**Bord Gáis Energy Response to
I-SEM Capacity Remuneration Mechanism –
Parameters Consultation**

(SEM -16- 073)

21st December 2016

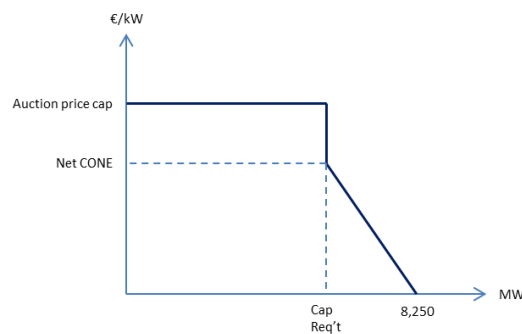
Of the three options proposed, BGE does not agree that any design fully balances the risk of system security and costs of over-procuring capacity. However, we believe a solution that would strike such a balance is akin to Option B whereby instead of an inflection point, the curve would reflect the Reduced EUE as a way of providing value to the customer. On that basis and in the interests of minimising volatility in the interim solution, we would suggest a simple linear reduction from Net CONE to a zero-crossing point at approximately 8,250MW. From a system security perspective, this approach would ensure that there is adequate generation capable of receiving a capacity contract beyond the capacity requirement. From a consumer cost perspective, the value of procuring additional capacity is captured given by showing that the zero-crossing point is in line with the reduced EUE curve. We illustrate our proposal in the Figure 1 below.

As per our answer to question 6.6.8 above, we believe that the shape of the demand curve for the first transitional auction should extend from Net CONE to a zero-crossing point at approximately 8,250MW. This solution would be akin to Option B but would also realise the costs to the consumer by reflecting the Reduced EUE curve whereby the value to the consumer is effectively zero at 8,250MW.
